Canister Storage Building Receiving Pit Modification Informal Design Verification

Project No: W-379

The design for modifications to the CSB Cask Receiving pit guides was verified by the informal design verification (meeting) method on August 9, 2000. The invited list of attendees and the meeting attendance sheet are included in attachment 1.

The design modifications that were reviewed are documented in ECN 654484 (attachment 2). The requirement that the design is to be verified against is to "***center the transportation cask sufficiently to allow installation of the guide funnel on the cask (+/- 0.25 inches or less)***".

18 CASK GUIDE SHIM PLATE

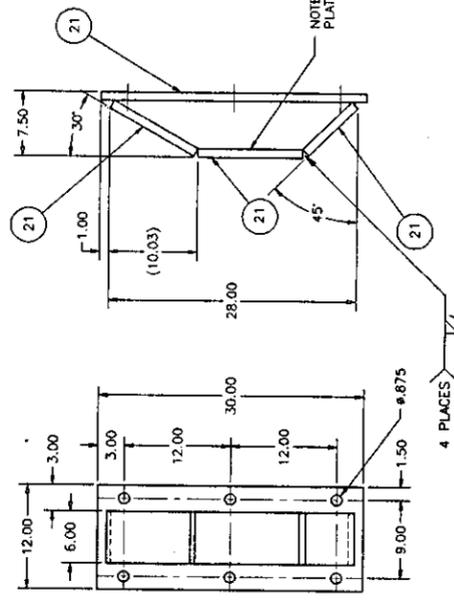
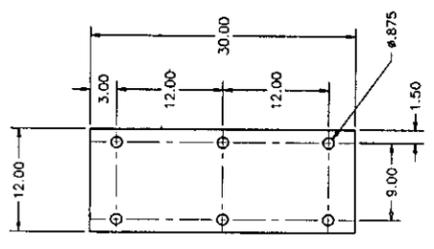
<p>12a. Modification Work</p> <p><input checked="" type="checkbox"/> Yes (fill out Blk.12b)</p> <p><input type="checkbox"/> No (NA Blks. 12b, 12c, 12d)</p>	<p>12b. Work Package No.</p>	<p>12c. Modification Work Complete</p> <p>_____ Design Authority/Cog. Engineer Signature & Date</p>	<p>12d. Restored to Original Condition (Temp. or Standby ECN only)</p> <p>_____ Design Authority/Cog. Engineer Signature & Date</p>
<p>13a. Description of Change</p> <p>13b. Design Baseline Document? <input checked="" type="checkbox"/> Yes <input type="checkbox"/> No</p> <p>Modify Cask guides in the Cask Receiving Pit to provide more accurate centering of the shipping cask as it is lowered into place. This accuracy is necessary to guarantee the required alignment between the cask opening in the shield hatch assembly and the MCO Guide. The modification will require adding a 1/2" shim plate behind each of the 8 cask guides.</p>

The tolerance on the OD of the transfer cask was discussed (+/- 1/8") relative to the clearance with the guides. As-built dimensions for the cask OD will be looked at to verify sufficient clearance exists with the maximum cask OD. The final design thickness of the shims under the guides will be based on the as-built cask OD dimensions and field measurements between the pit guides.

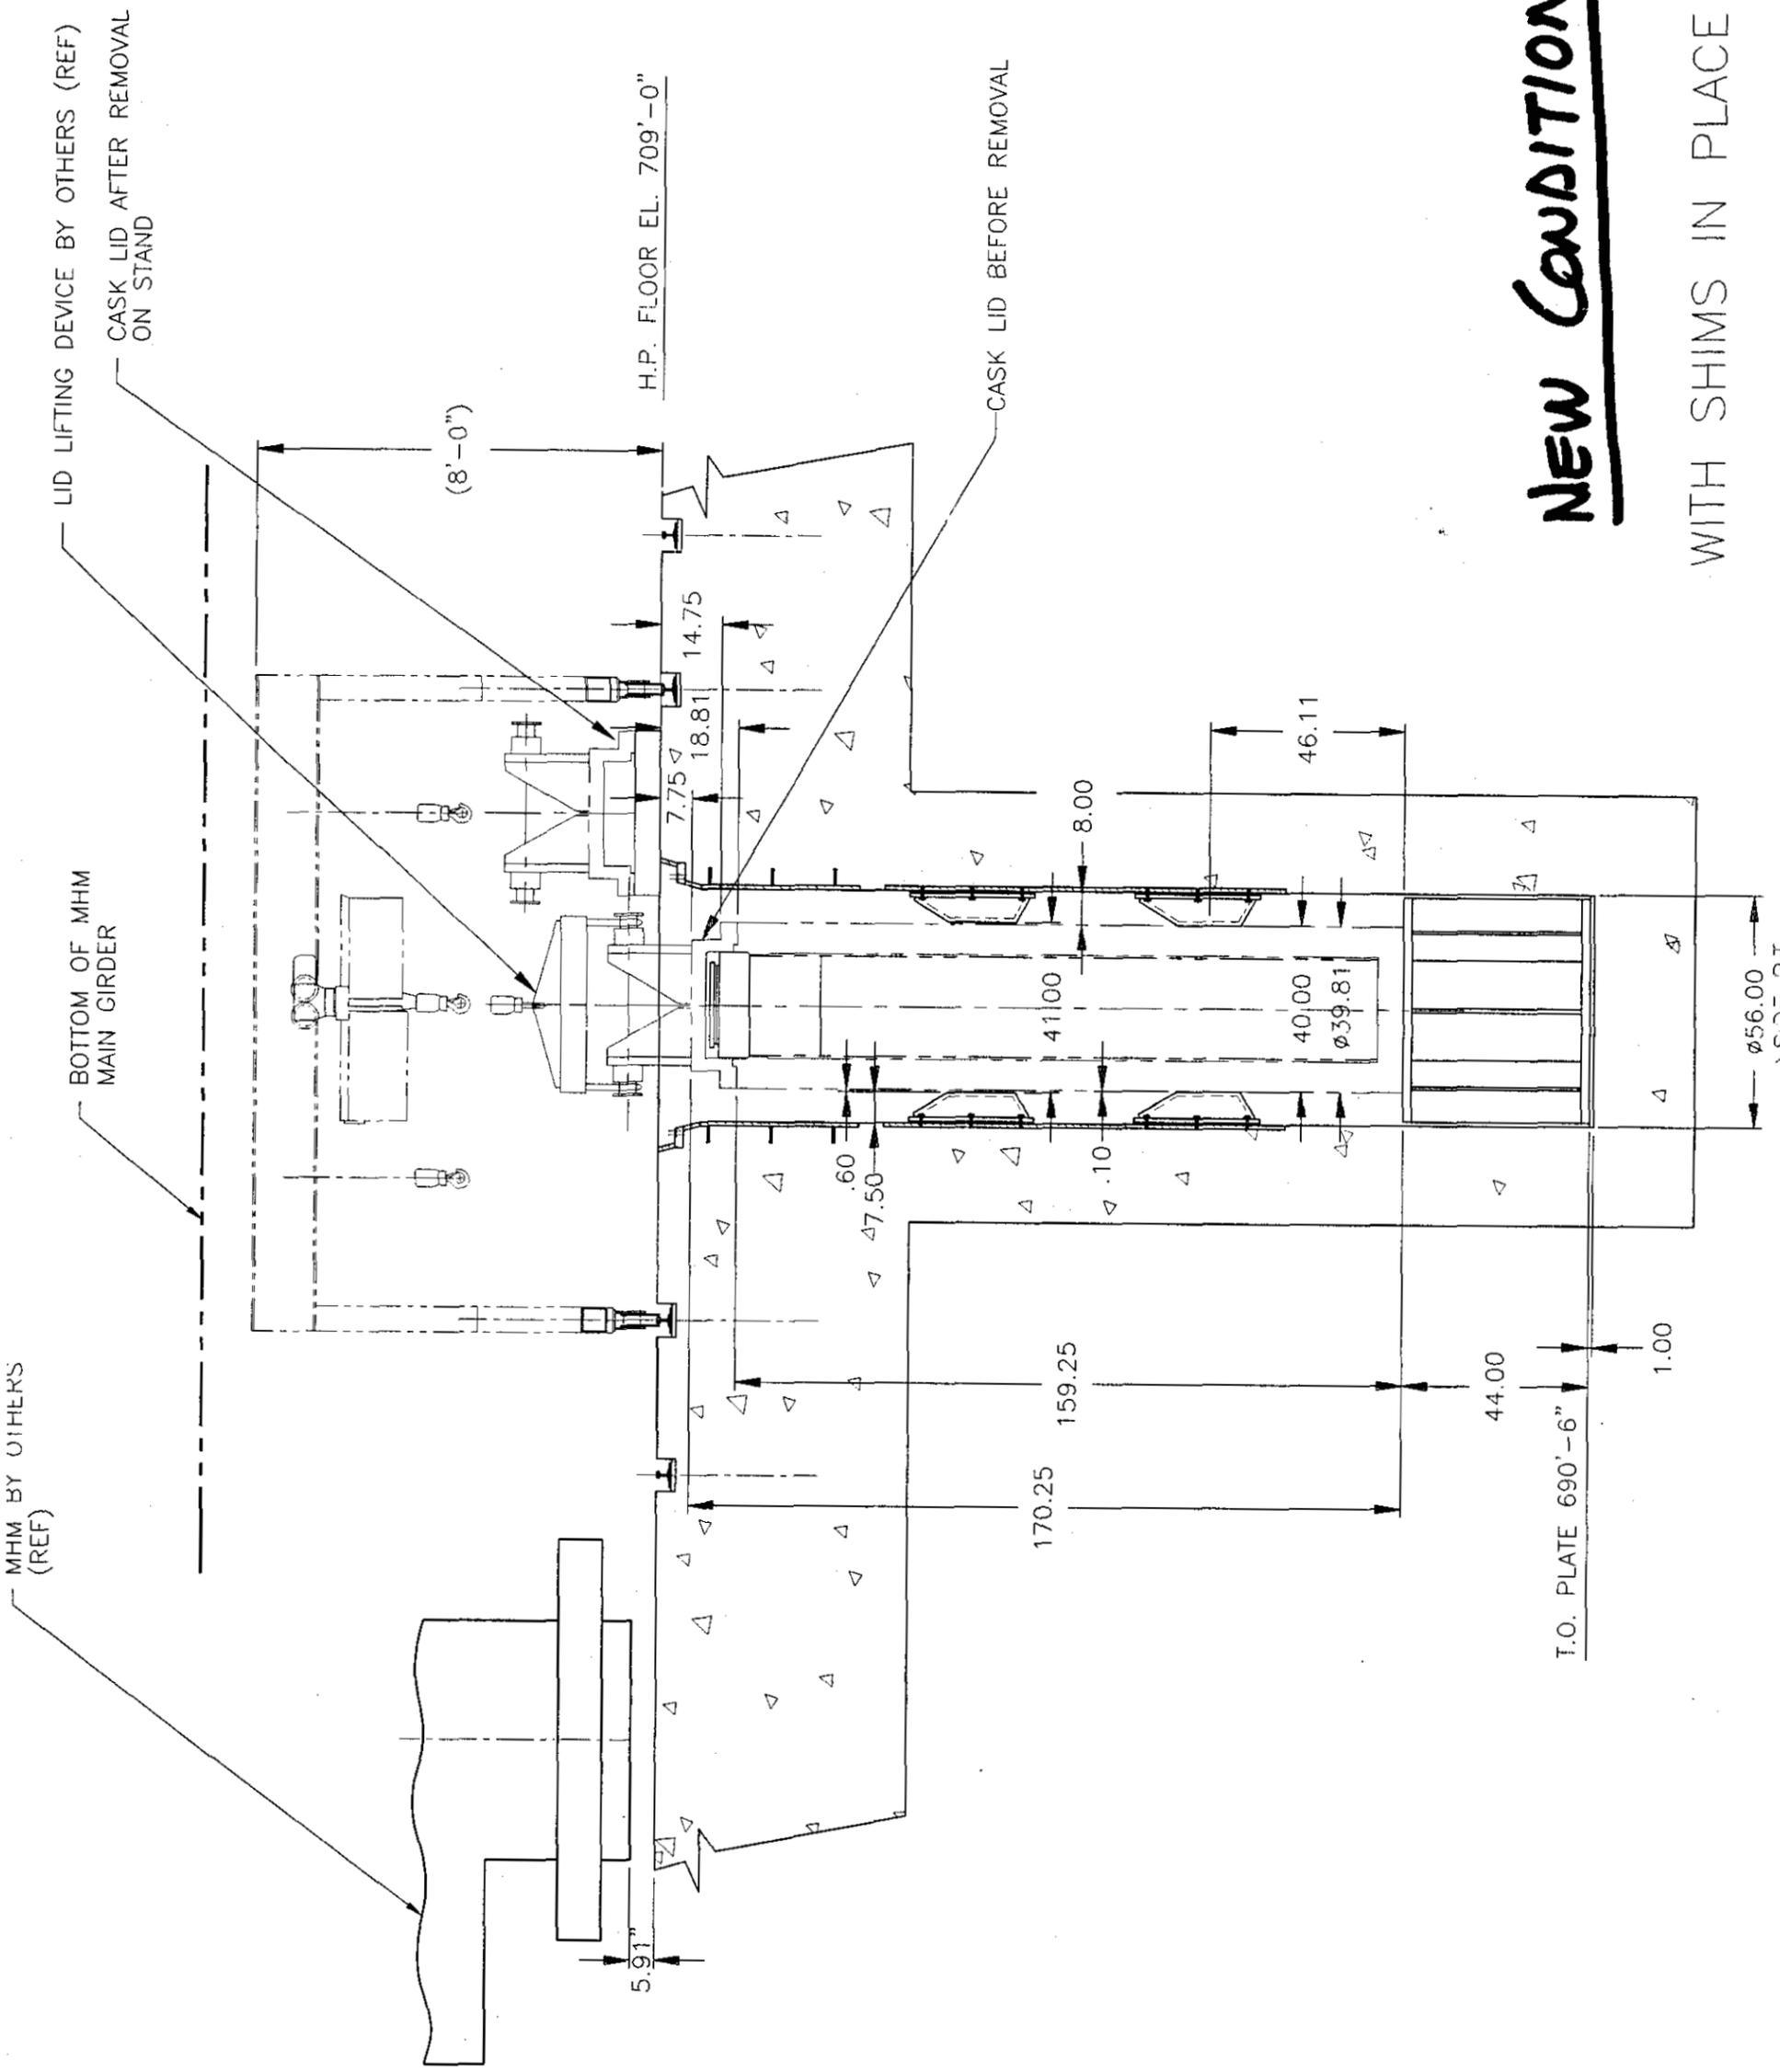
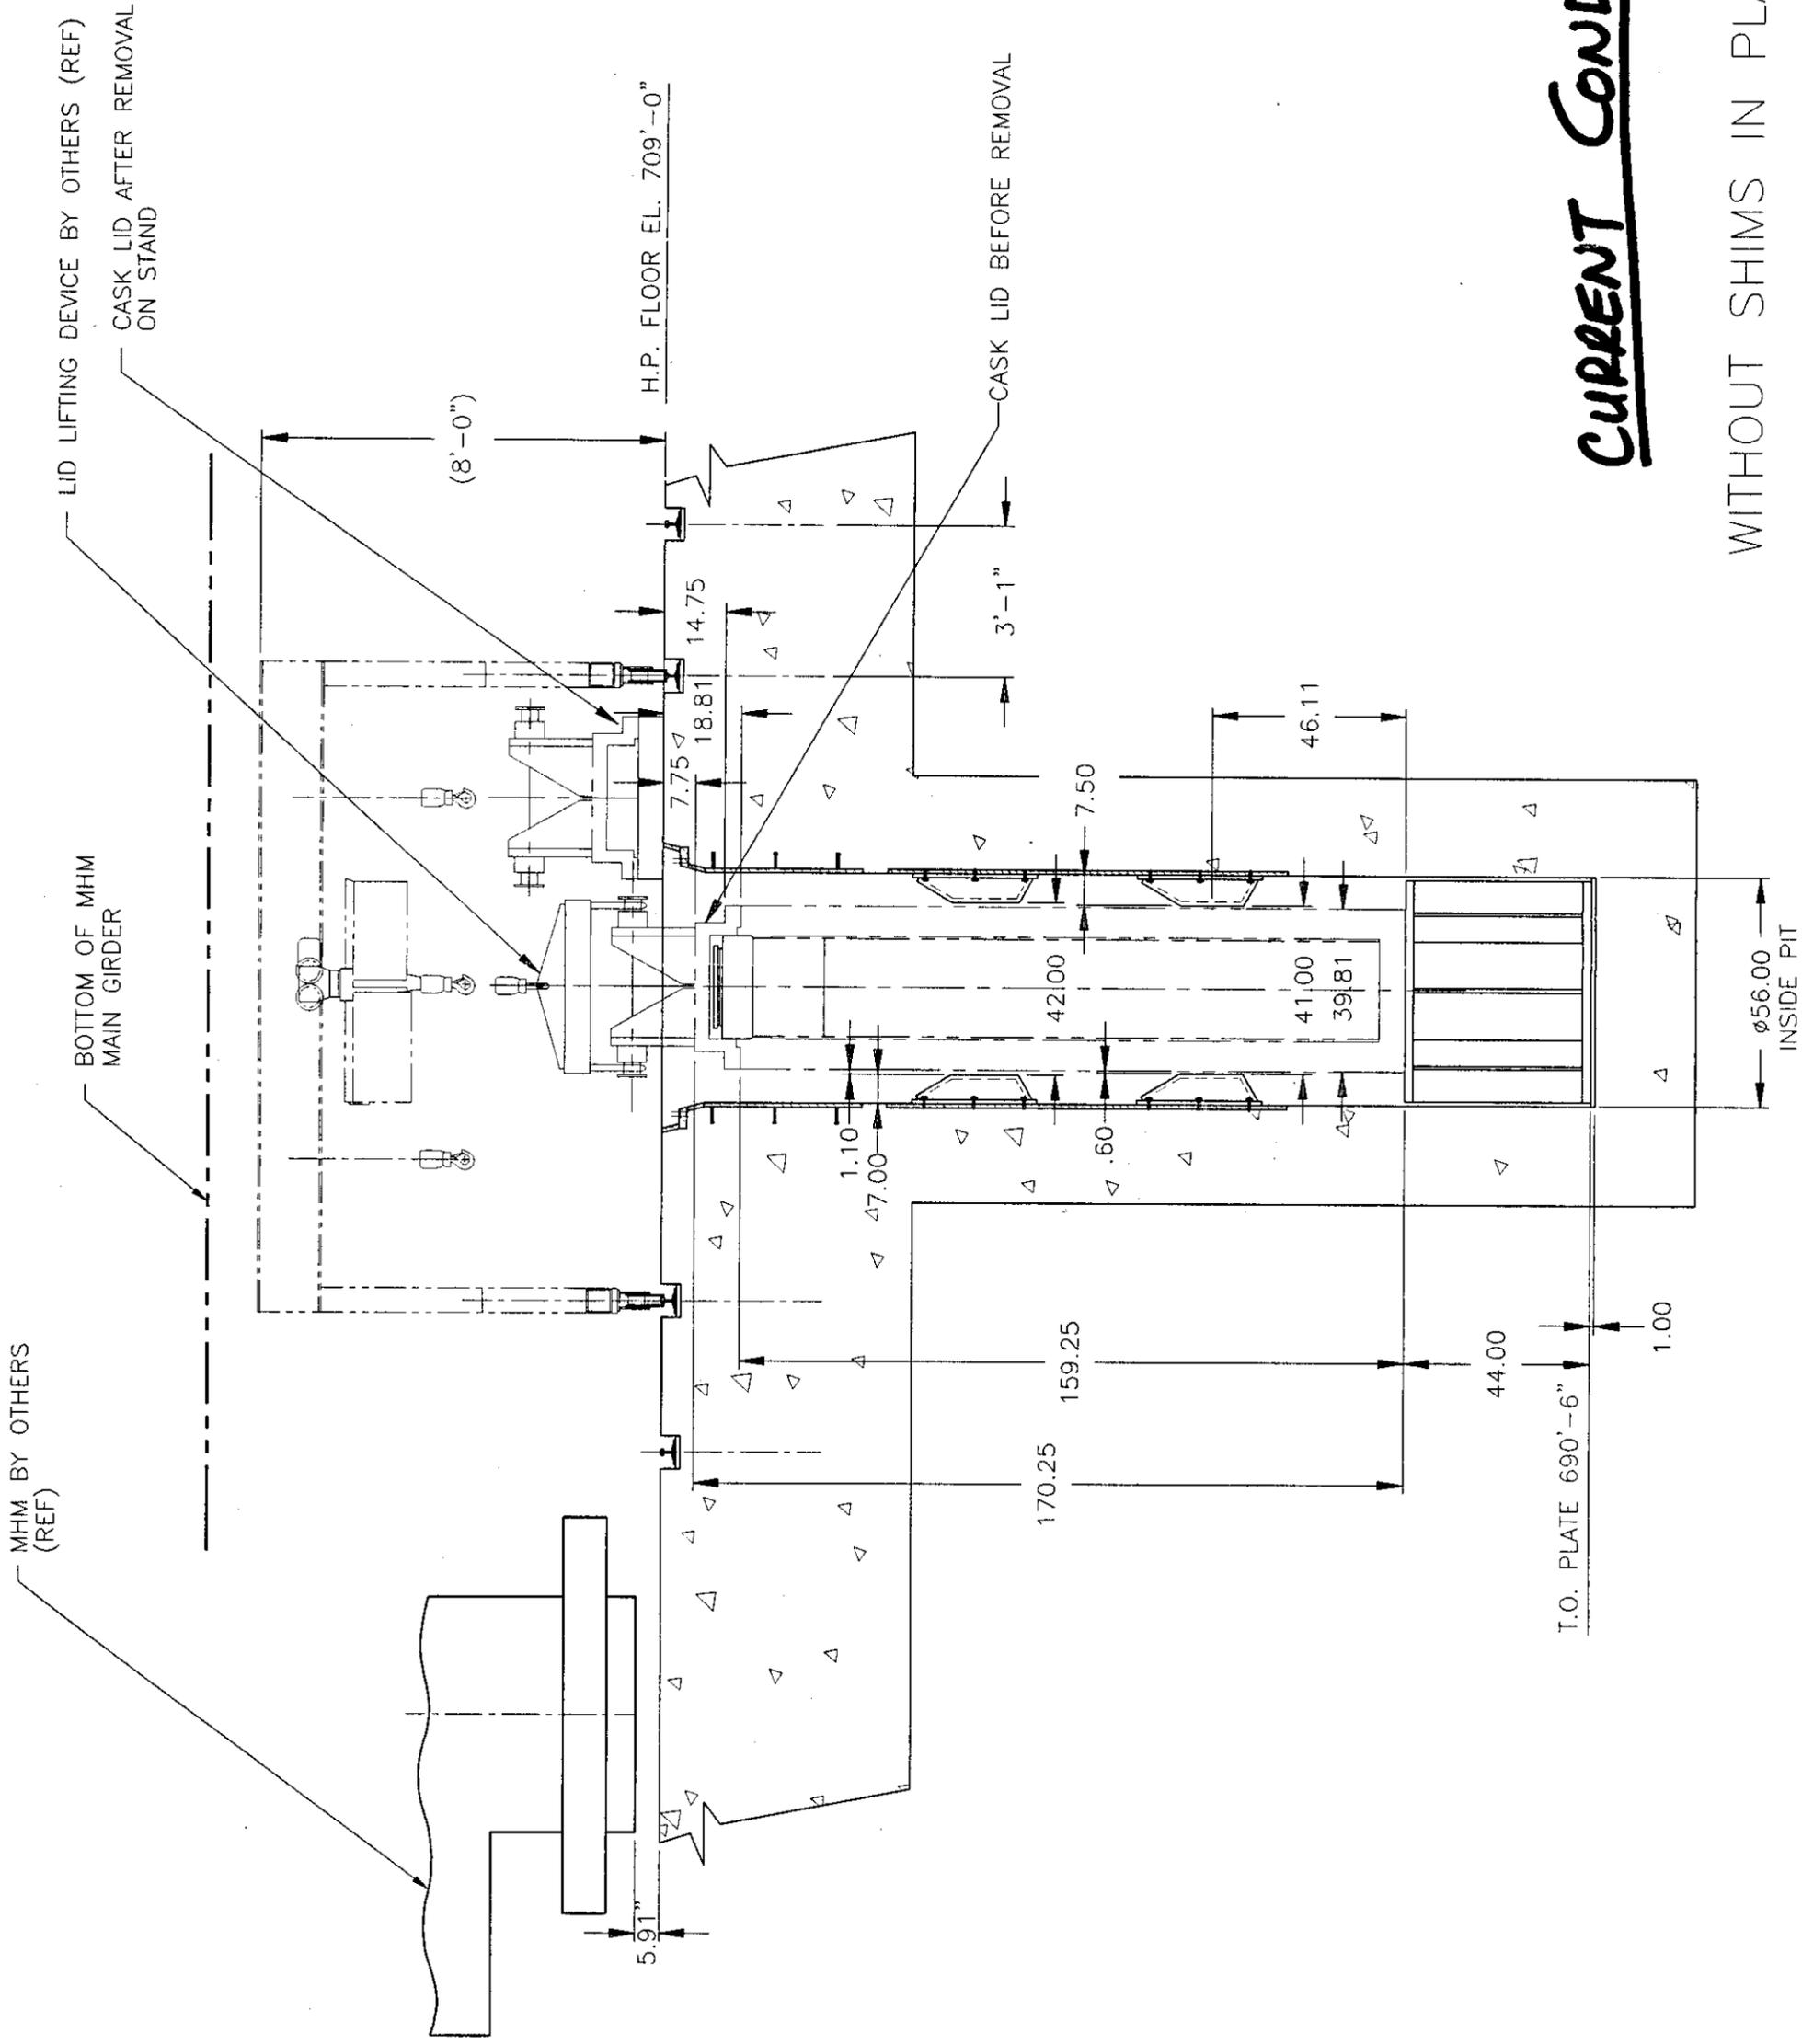
NEW CONDITION

WITH SHIMS IN PLACE

CURRENT CONDITION

WITHOUT SHIMS IN PLACE
